MINUTES OF THE MEETING OF CITY OF PARRAMATTA COUNCIL HELD IN THE CLOISTER FUNCTION ROOMS, ST PATRICK'S CATHEDRAL 1 MARIST PLACE, PARRAMATTA ON MONDAY, 11 FEBRUARY 2019 AT 6.30PM

13.4 SUBJECT Gateway Request – Planning Proposal – 18 – 40
Anderson Street, Parramatta

ITEM NUMBER	13.4
SUBJECT	Gateway Request – Planning Proposal – 18 – 40 Anderson Street, Parramatta
REFERENCE	RZ/4/2018 - D06585010
REPORT OF	Project Officer- Land Use Planning

ITEM NUMBER	6.1
SUBJECT	Gateway request – Planning Proposal – 18 – 40 Anderson Street, Parramatta
REFERENCE	RZ/4/2018 - D06537300
REPORT OF	Project Officer- Land Use Planning
LAND OWNER:	Australia and New Zealand International Investment Group Pty Ltd
APPLICANT:	Landream

Figure 9: The proposed design concept. A new park and green link is shown on the southern part of the site

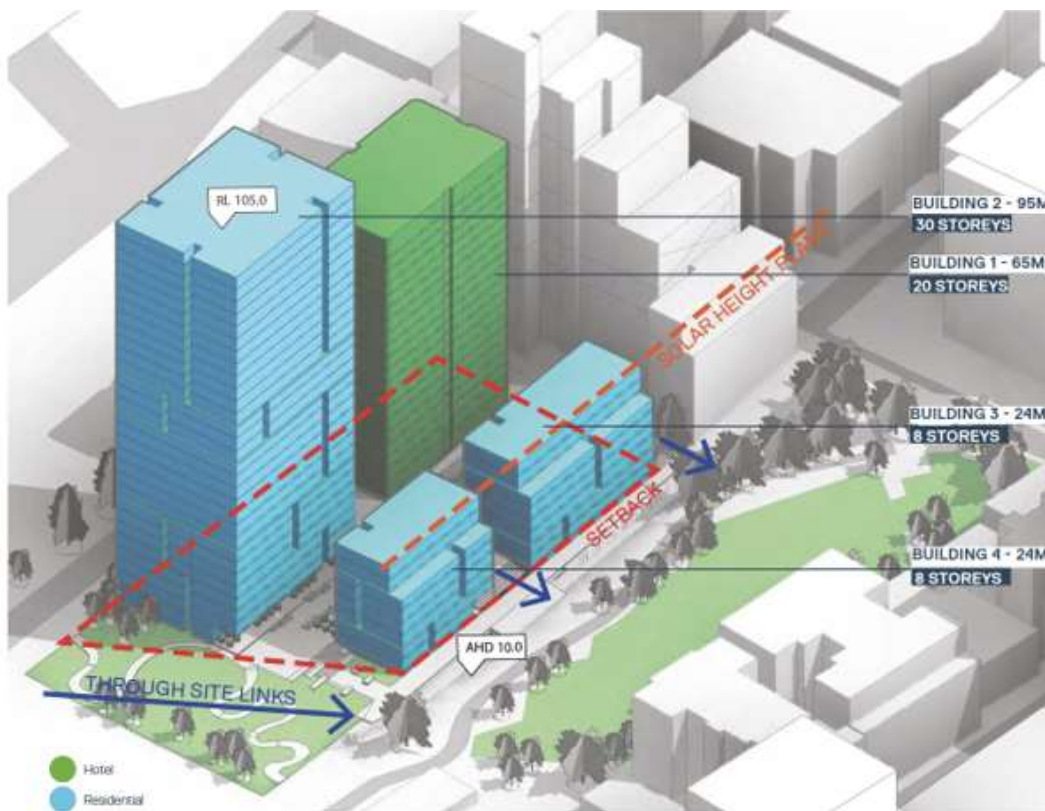
- The building separation of the proposed towers in the original design is 12 metres (See Figure 9)– two towers have been located with minimal separation to achieve an FSR 6:1 – this is not supported and may not meet Apartment Design Guidelines. A scenario with one taller tower and 6-8 storey street wall buildings around a courtyard will result in improved separation, amenity and views. An alternative scenario with two towers, one up to 120 metres in height and the second tower fronting Anderson Street of a lesser height may also be considered. Preliminary modelling prepared by the Urban Design Team suggest that a 120m tower can be located on site whilst still protecting Jubilee Park from overshadowing. The site-specific provision to be included in the Planning Proposal regarding overshadowing of Jubilee Park will reinforce the solar access protection. The two tower scenario is shown in **Figure 10**

Figure 11: Revised development concept submitted by applicant. Blue represents residential floor space and yellow represents non-residential floor space

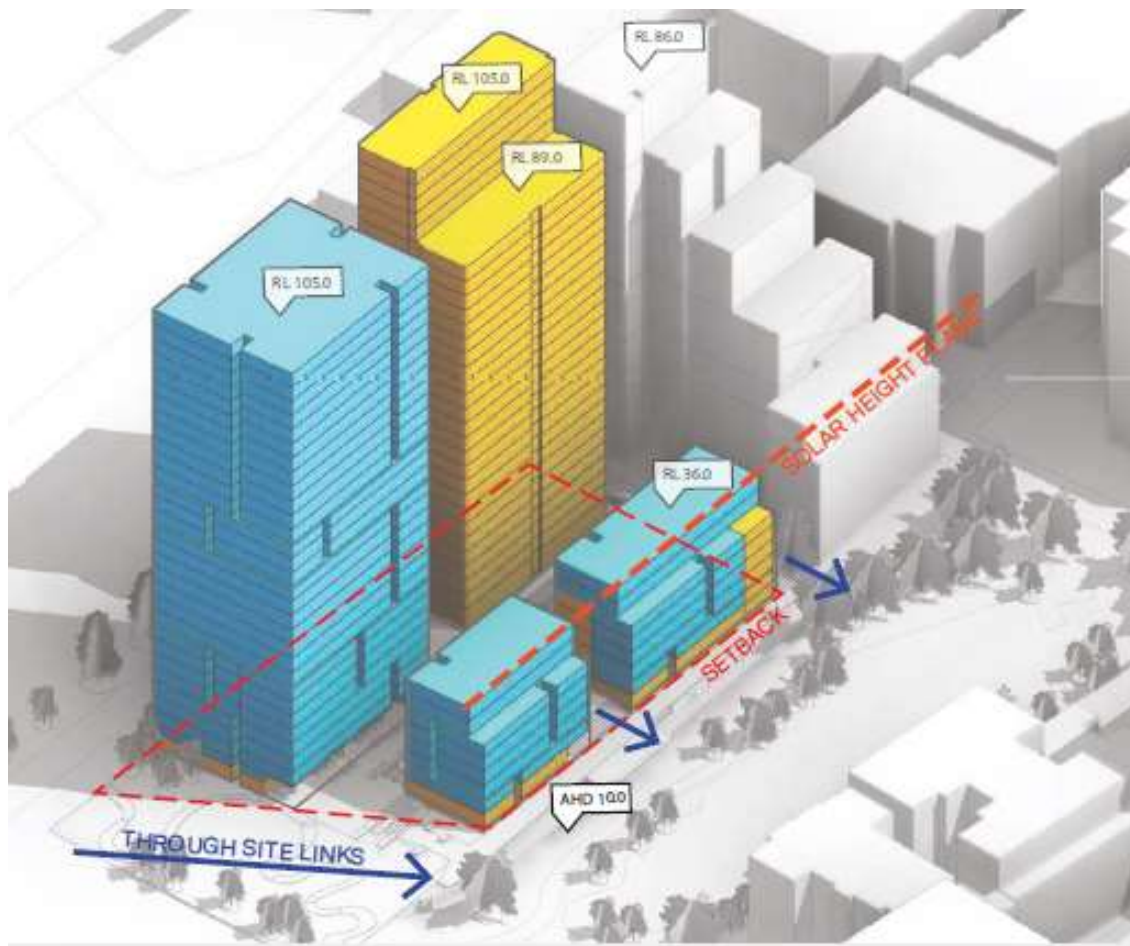
26. In the Planning Proposal originally lodged by the applicant the proportion of residential space was 69 percent of the total floor space and non-residential floor space was 31 percent. In the revised proposal, non-residential space has been increased to 43 percent of the total floor space and residential space has been reduced to 57 percent.

35. Therefore, the provision in the development concept for non-residential floor space of 43 percent and residential space of 57 percent is considered acceptable as:

Figure 13: Revised flood mitigation and water management proposal

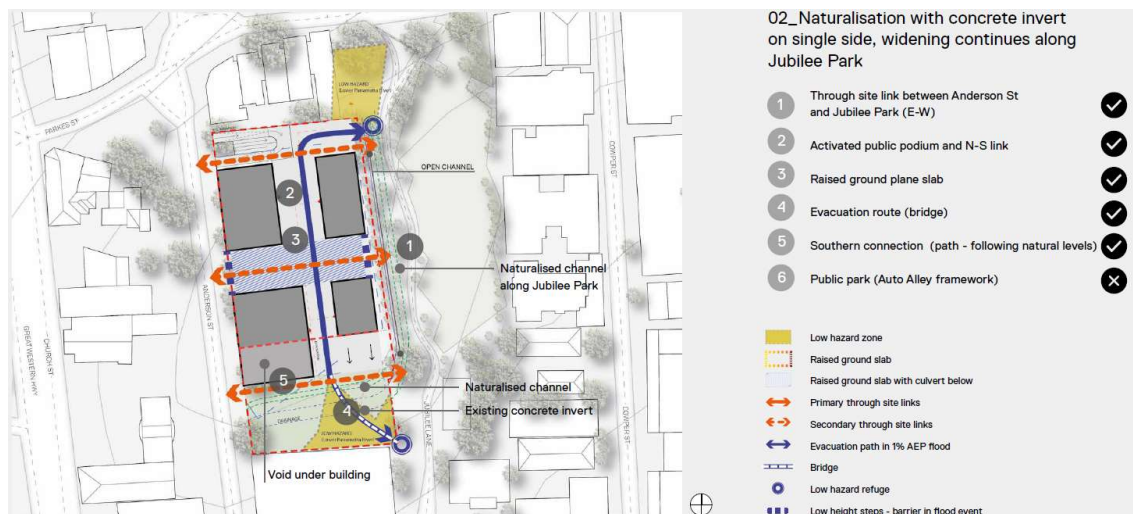
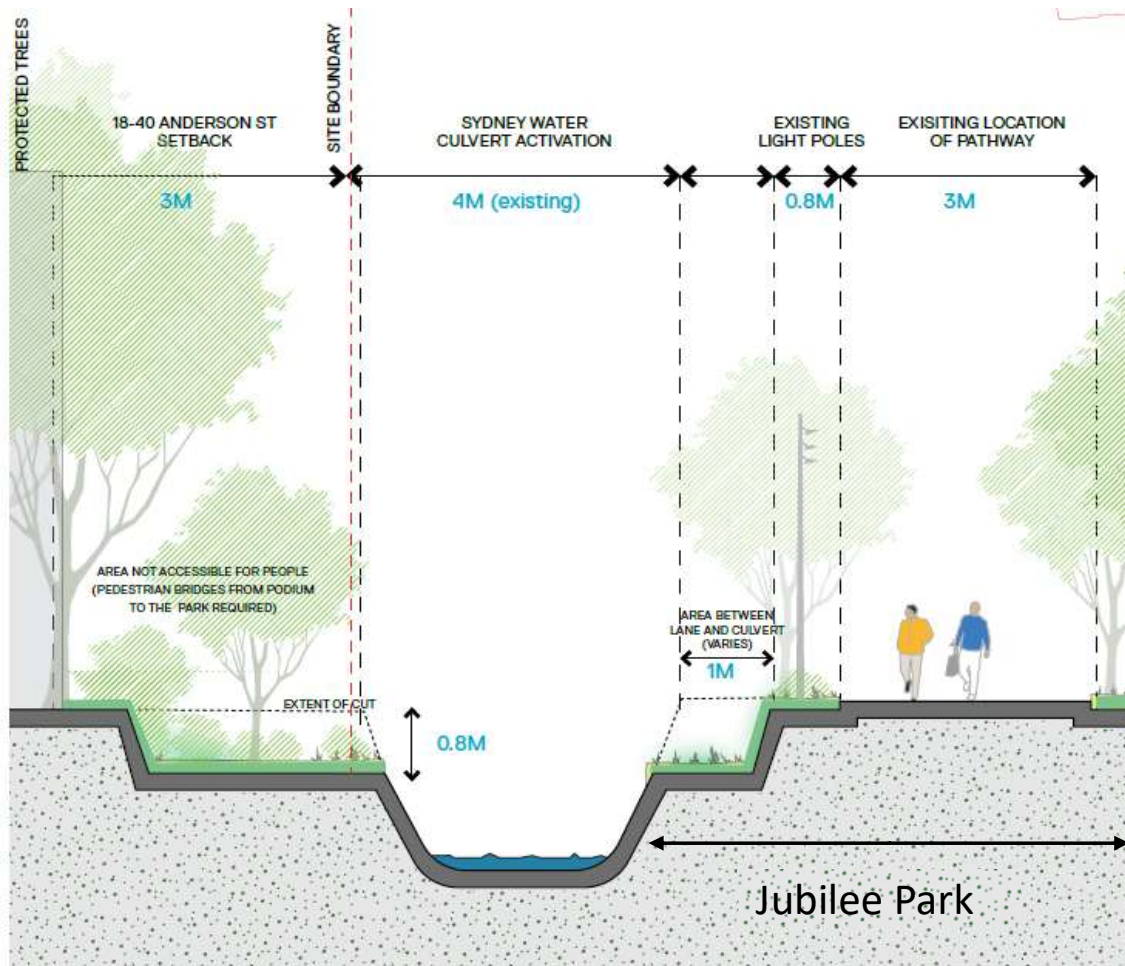
50. City staff considered that in principle the revised concept has the potential to address the flood risk issue in a manner that minimises flood risk to future occupiers of the site and the broader community. Nevertheless, there are some concerns about the details of the concept that can be resolved with the progression of the Planning Proposal and a site-specific DCP. The proposal to widen the channel into Jubilee by 1m along its western edge (as shown in Fig 14 above) will increase the risk to park users by providing landscaping that attract people to the high hazard, 100 year/floodway zone. City staff also do not support the benching of Jubilee Park as it will reduce the area of contiguous usable open space. The eastern edge of the channel, alongside Jubilee Park, should remain more or less as it is now. Instead, the channel can be widened and deepened on the western side of the culvert within the applicant's site.

51. It is considered that the site is generally suitable for residential development from a flood risk perspective subject to resolution of details of the flood mitigation measures, in consultation with Sydney Water, prior to public exhibition of the Planning Proposal. The Planning Proposal is considered to be capable of being consistent with Section 4.3 Flood Prone Land of the Section 9.1 Ministerial
